# OCP Amending Bylaw Feedback 20738 - 123 Ave

File # 2013-041-RZ

HUB, Maple Ridge/Pitt Meadows

Dec 9, 2014

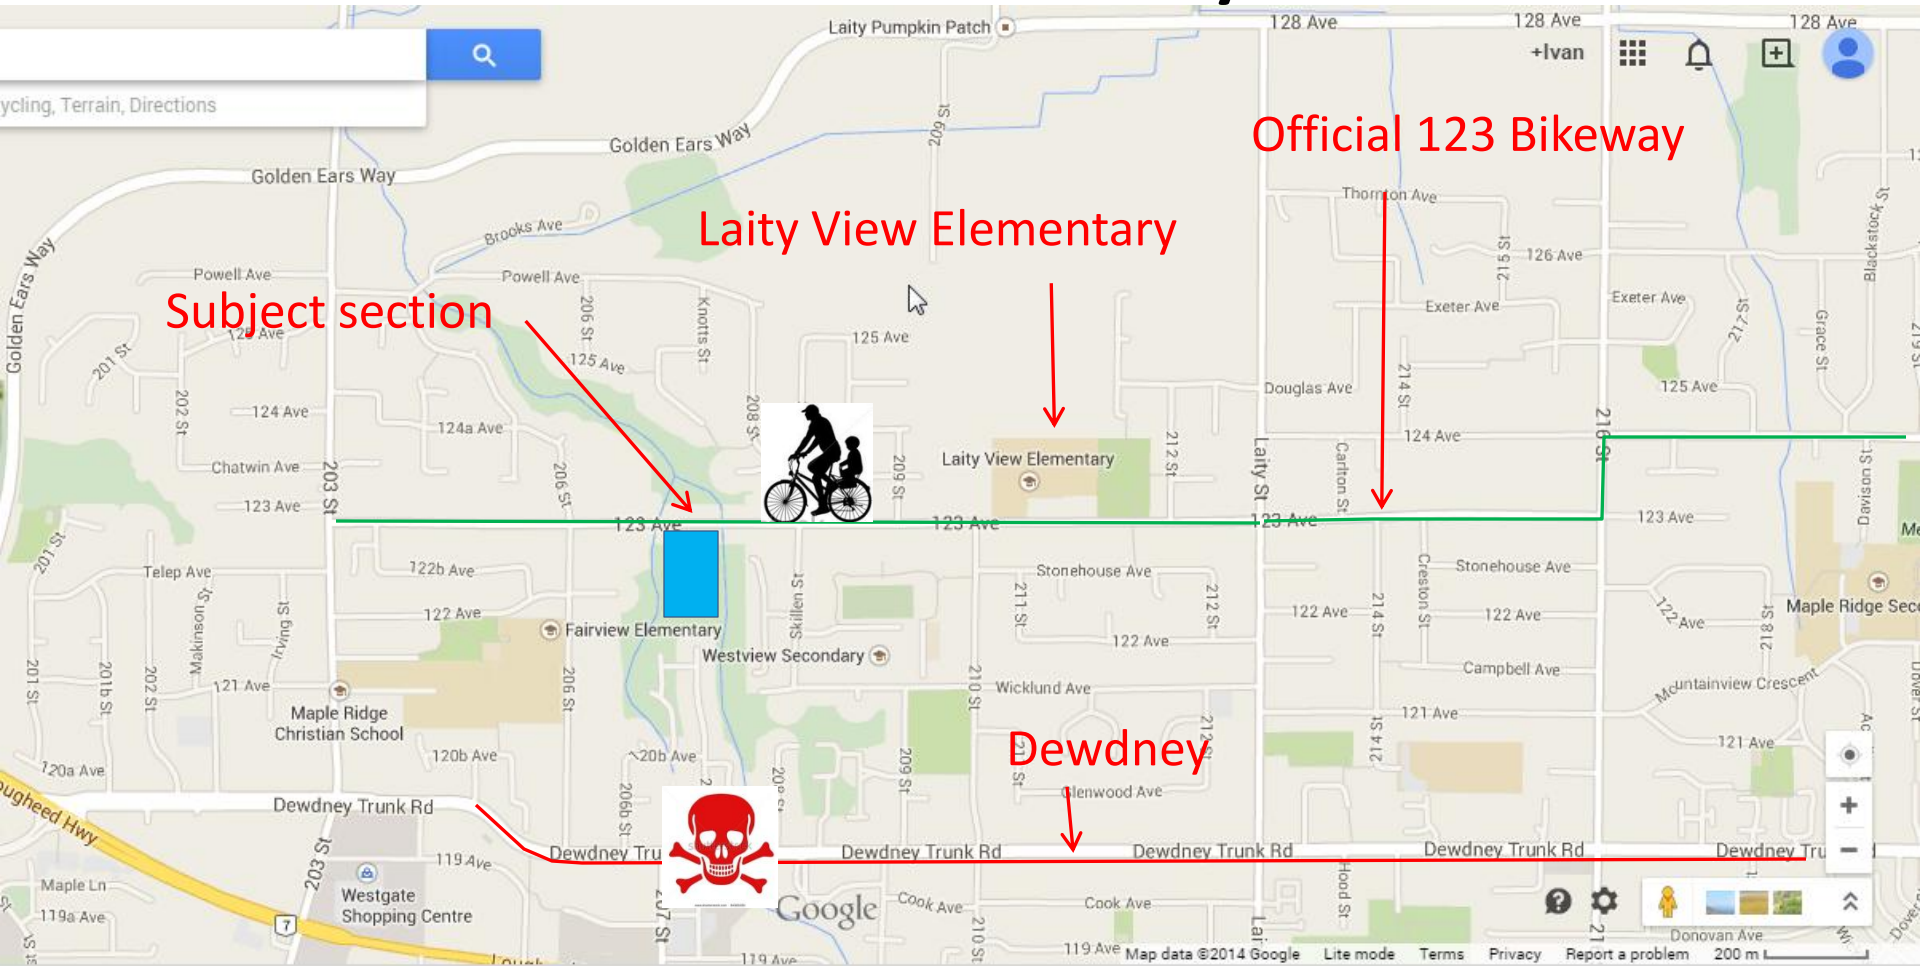
Proposed variance #1 to reduce 123 Ave collector road right of way from 20m to 16 m

That Variance #1 not be granted

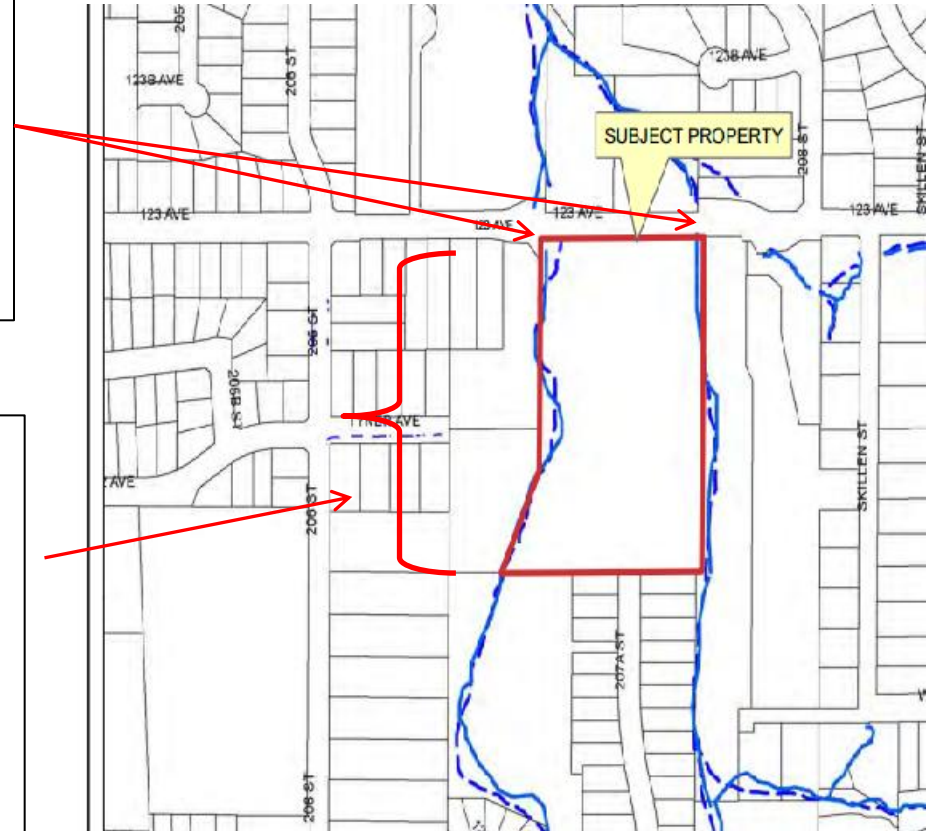
To minimize the impact on McKenney Creek

Applicant also proposes variance to reduce setback requirement from 30m to 12 – 22.5m along entire length of both creeks to maximize development potential
